AGENDA PLANNING COMMISSION MEETING

October 2, 2025 - 6:00 PM
City Hall Council Chambers

To: Planning Commission
From: Kris Jenson, Planning Manager
Date: September 23, 2025
Subject: Packet Material for the October 2, 2025 Planning Commission Meeting
Agenda Item: Taco Bell Conditional Use Permit
Action Deadline: October 19, 2025

To: Planning Commission
From: Kris Jenson, Planning Manager
Date: September 22, 2025
Subject: Packet Material for the October 2, 2025 Planning Commission Meeting
Agenda Item: Ritter Meadows amenity building conditional use permit

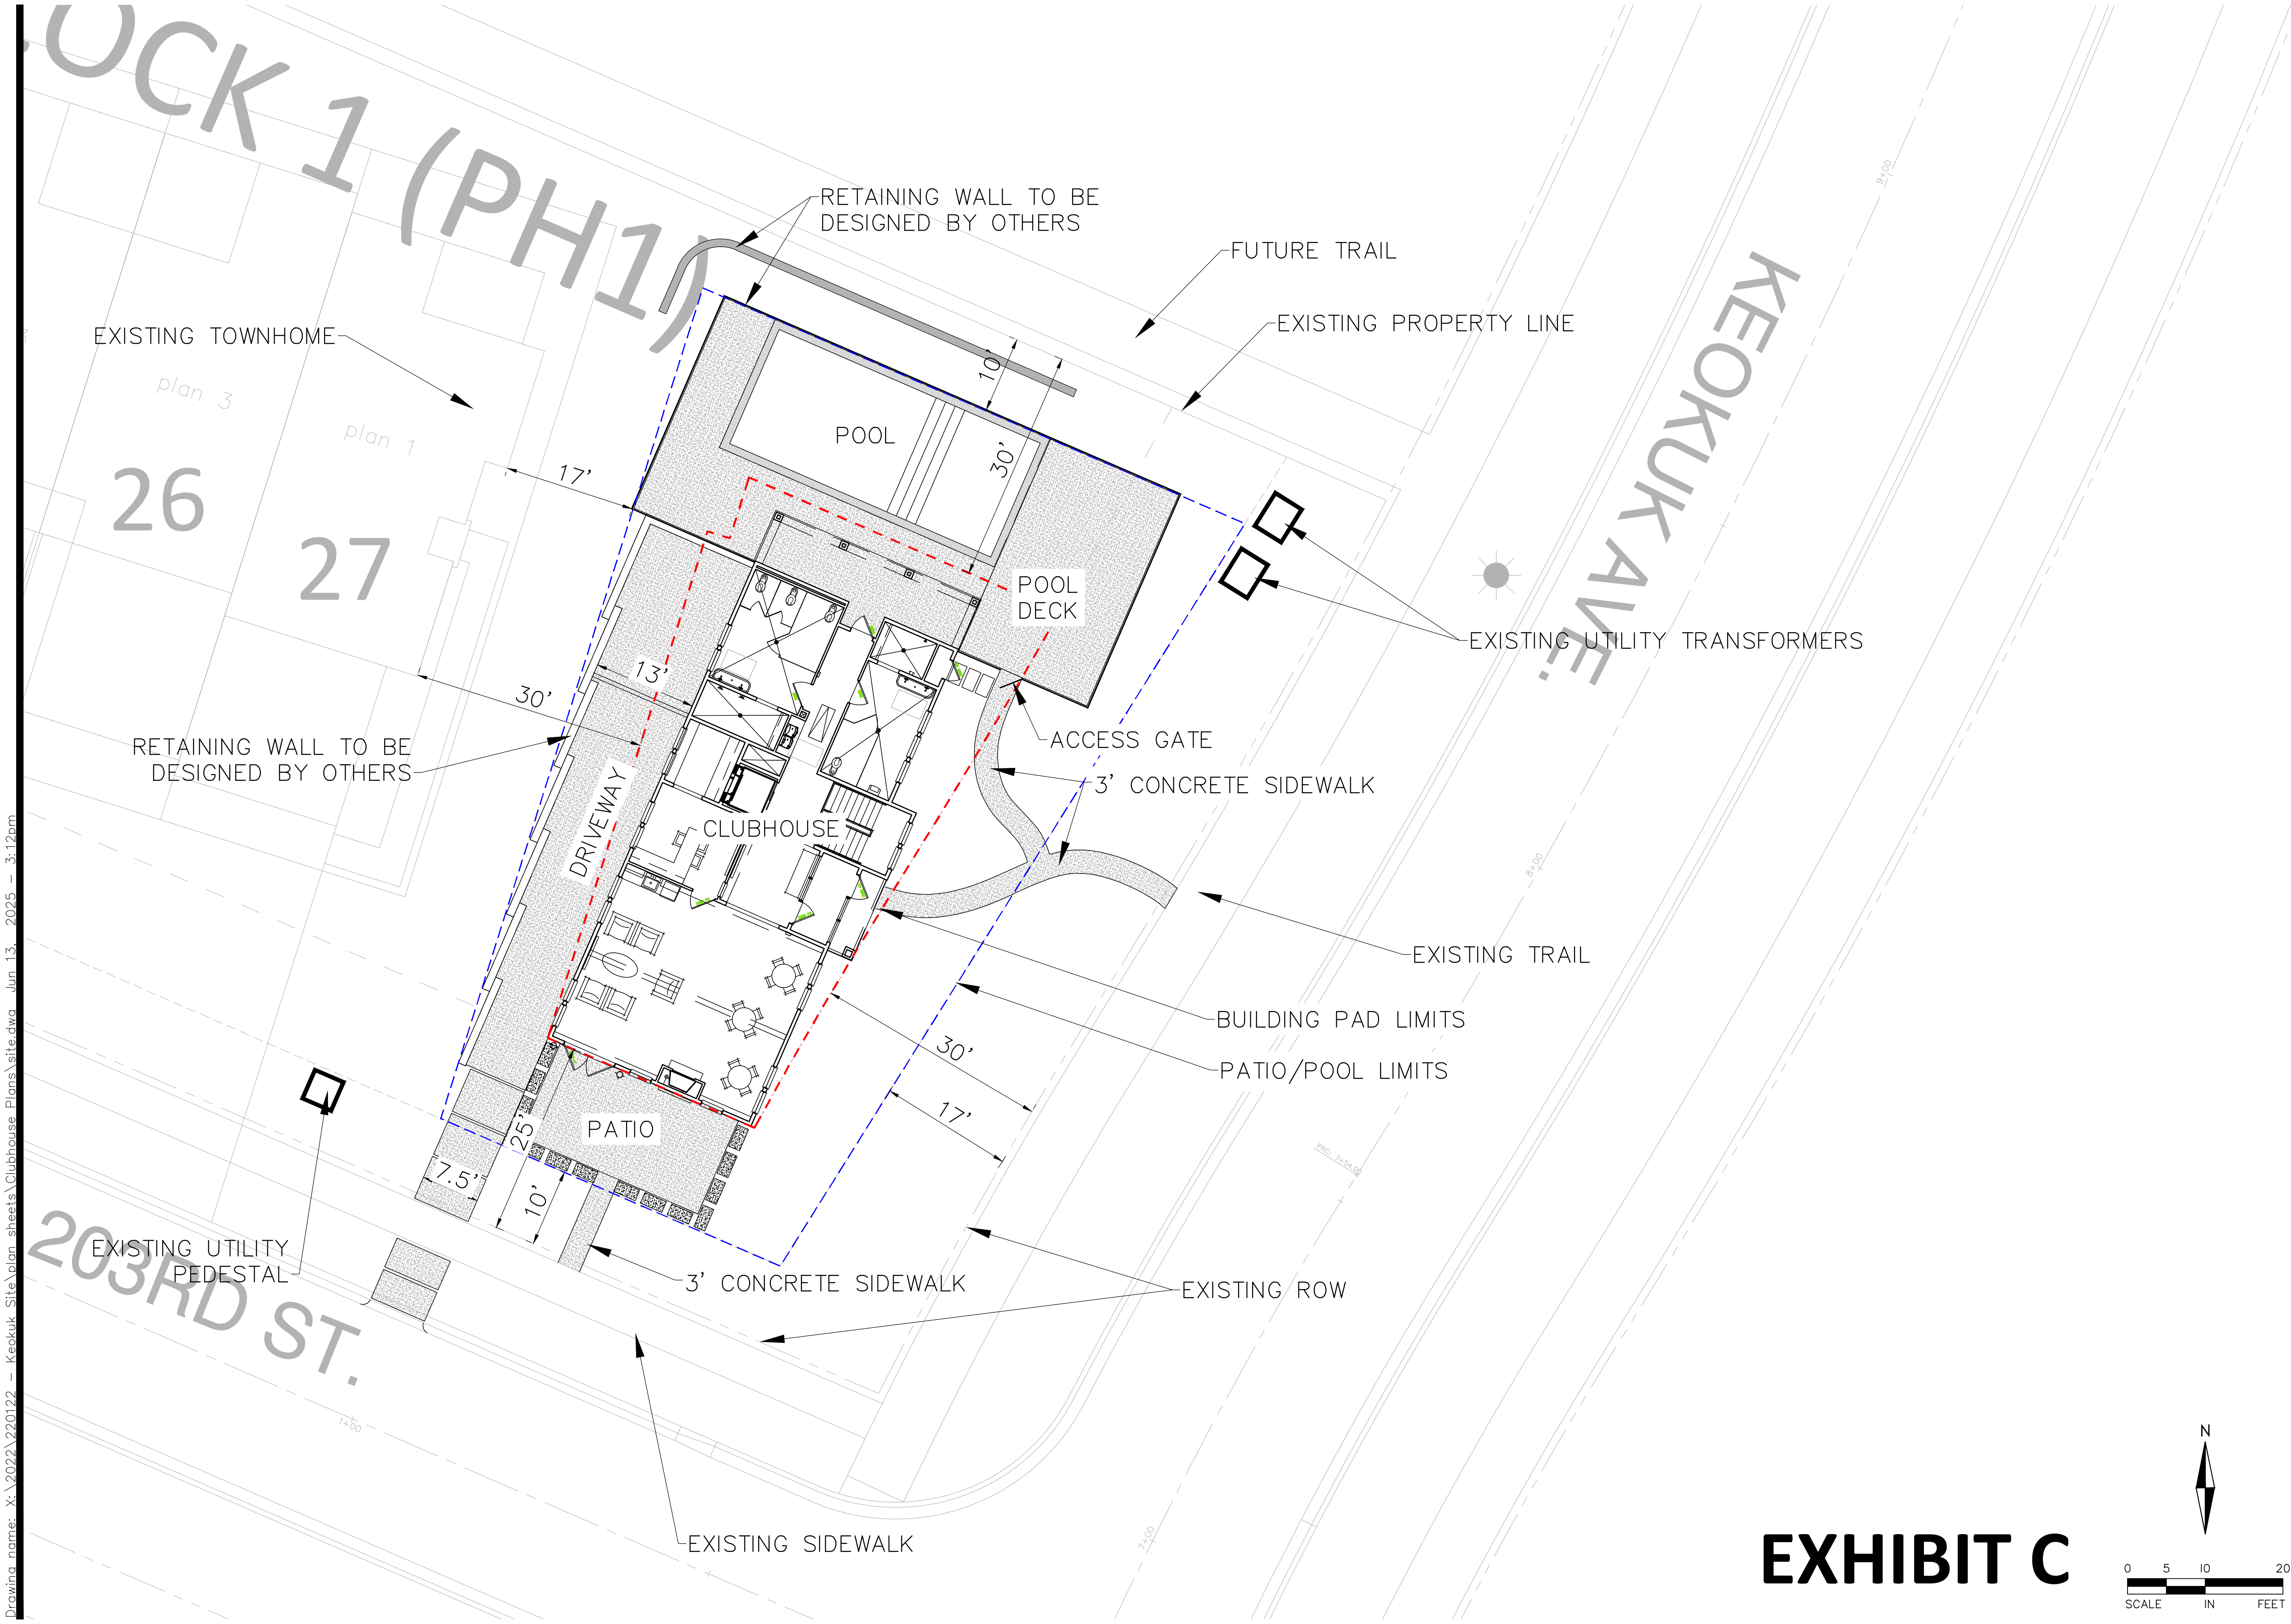
Site Plan. Access to the building and pool area is via sidewalk that extends from the trail along Keokuk Avenue. There is also a sidewalk from 203rd Street to the patio on the south side of the building. Along the west side of the building, a narrow eight-foot-wide driveway drops down to provide access to an overhead door of the lower-level maintenance garage. A retaining wall is required along the west side of the driveway and will be 8 feet 6 inches at the bottom of the driveway. A fence shall be placed on top of the retaining wall and engineered plans of the wall will be required with the building permit as the wall exceeds four feet in height.

The swimming pool will be surrounded on three sides by a concrete deck and enclosed by a fence, which must meet the requirements for swimming pool protection within Section 11-21-5.G of the Zoning Ordinance. The developer has indicated that they plan to use an aluminum fence in a wrought iron style, though a privacy fence may be used along the west side of the pool to provide additional screening and privacy to the adjacent townhome. The pool location meets the 10-foot setback from the north property line.

Lighting. The site plan does not indicate pole lighting on the property. Building mounted lighting at several points around the building; no other lighting is shown on the site. All lighting must be downcast and may not shine onto adjacent properties.

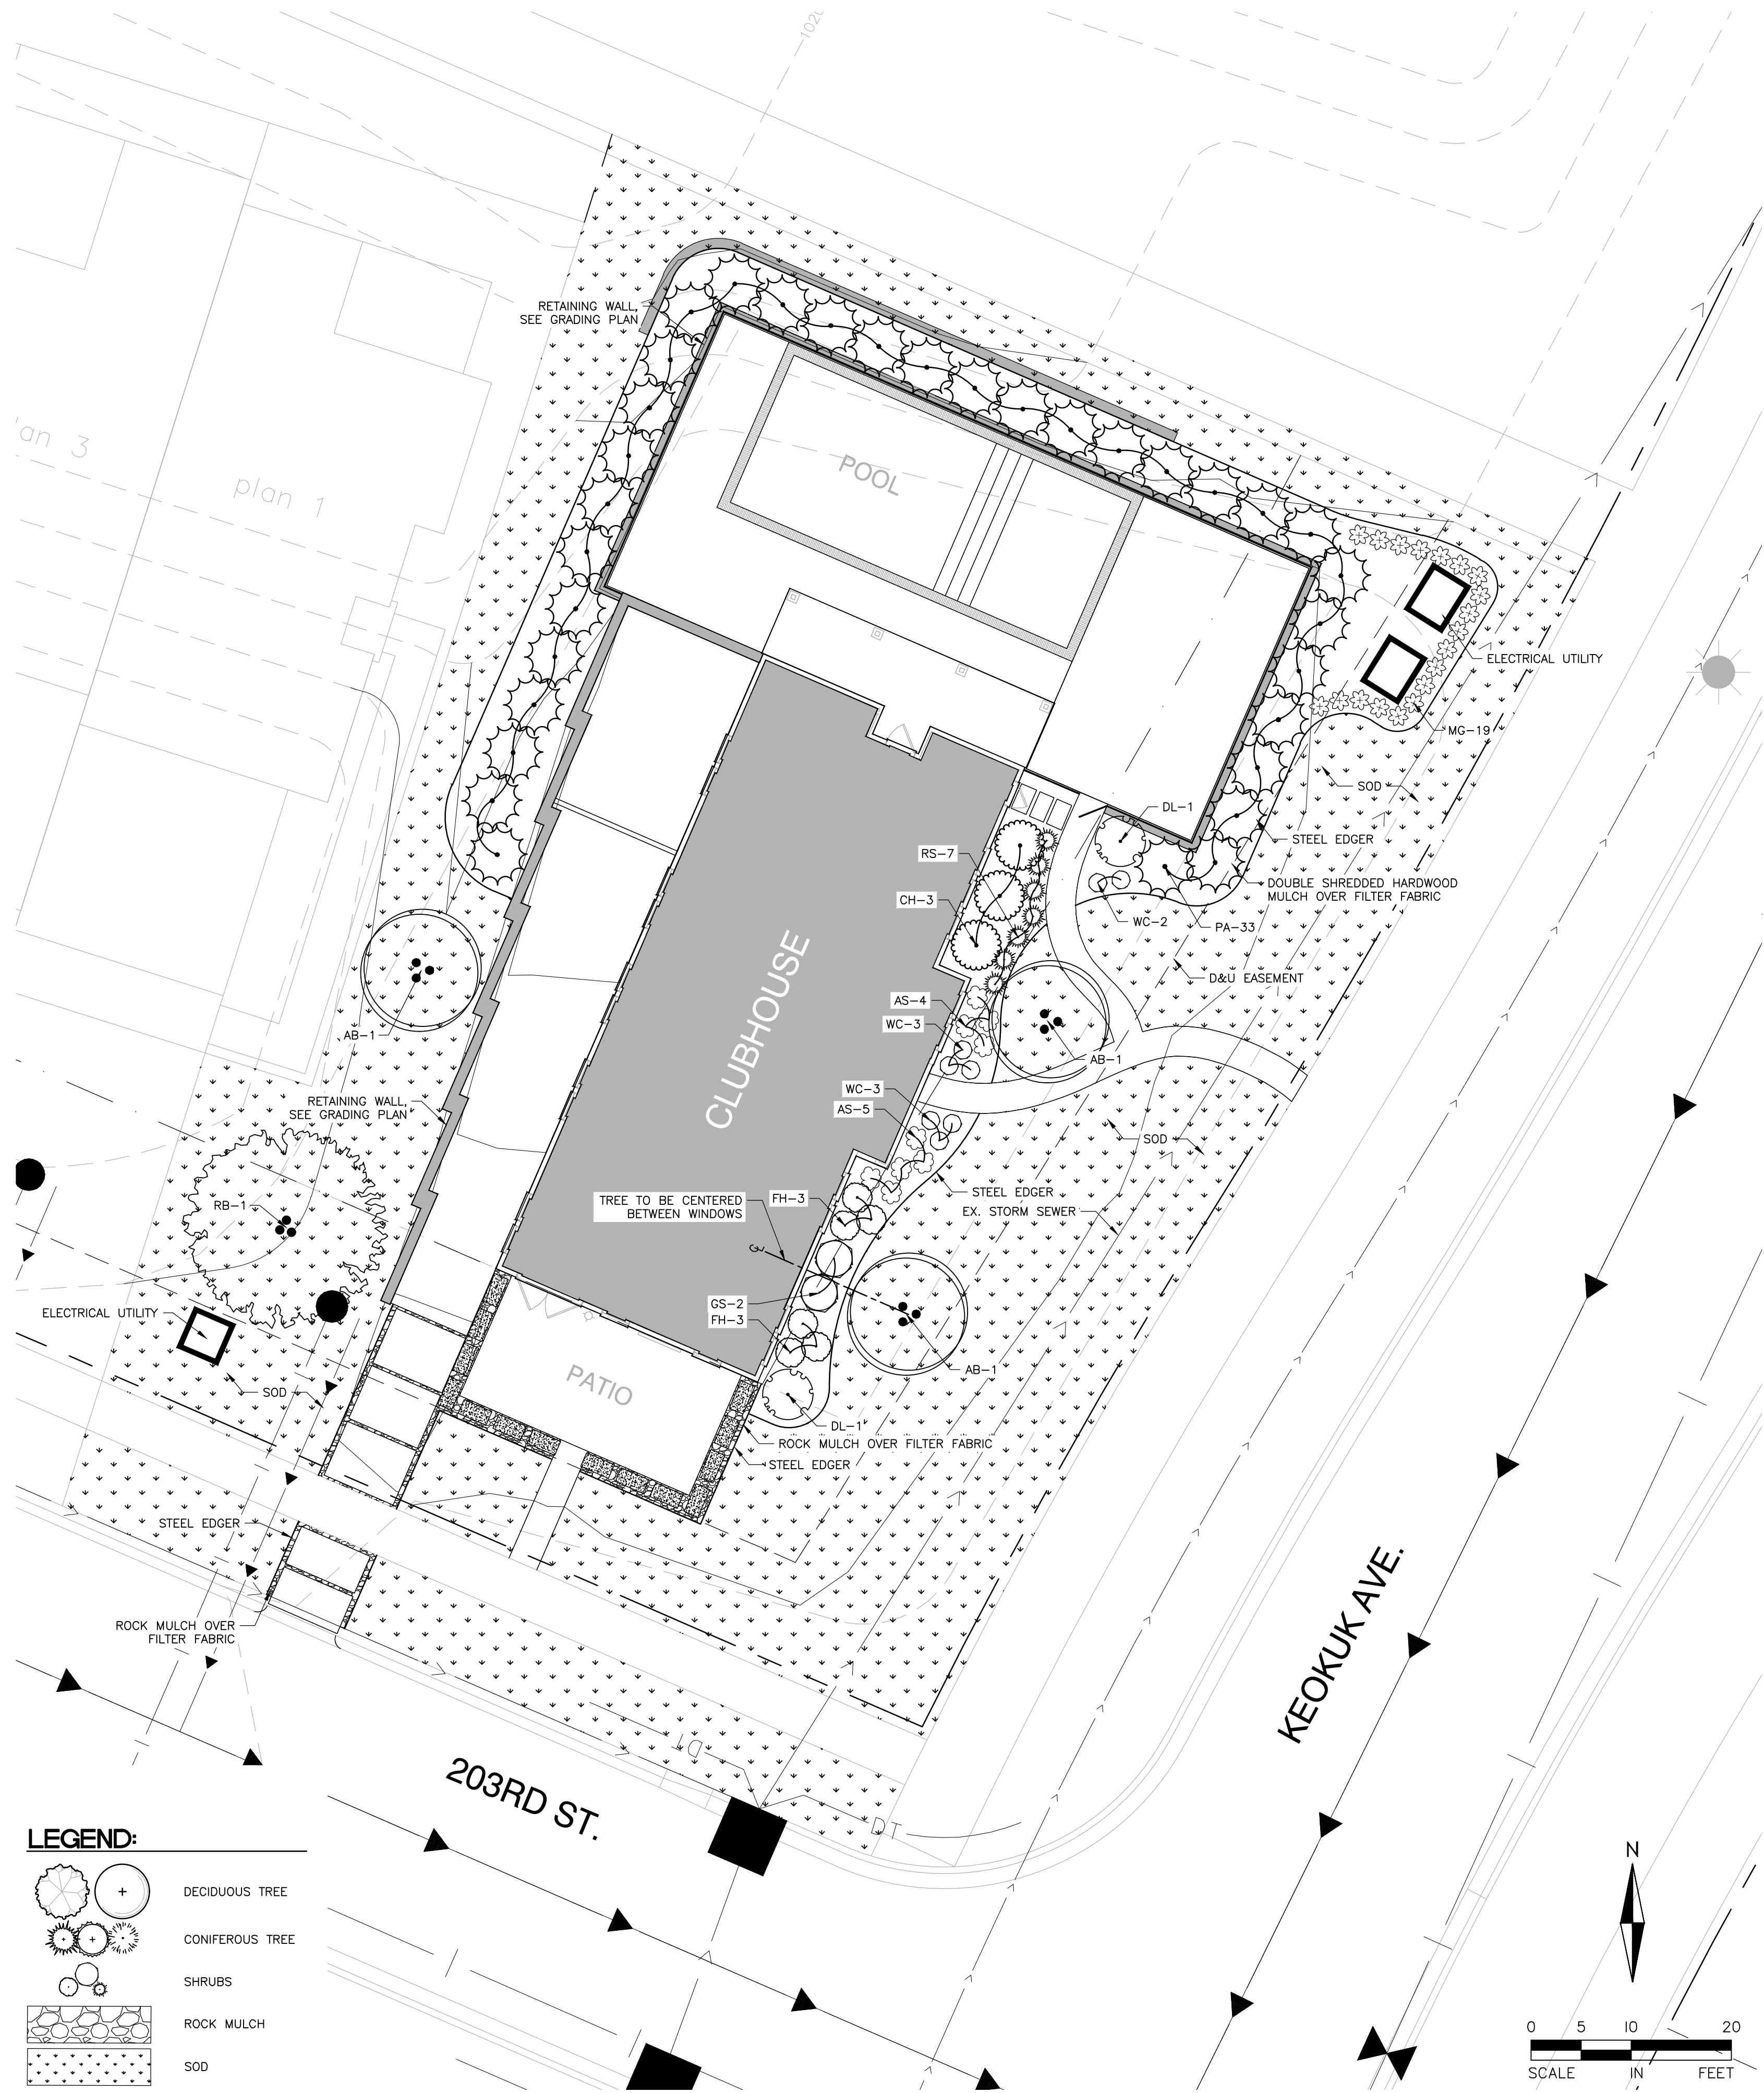
Landscaping. Plantings are proposed along the front (east) elevation of the building and arborvitae trees are proposed to be planted around the pool area and extending 30 feet of the driveway access, which will provide screening of the site for the adjacent townhome building. The site will be irrigated in compliance with Section 11-21-9.4.e of the Zoning Ordinance. A security based on the materials and installation costs of the approved landscape plan shall be submitted with the building permit. The City Forester reviewed and had no comments on the landscape plan dated June 13, 2025. Plantings on the site must be installed per the plan and an as-built landscape plan submitted prior to inspection of the landscaping on site.
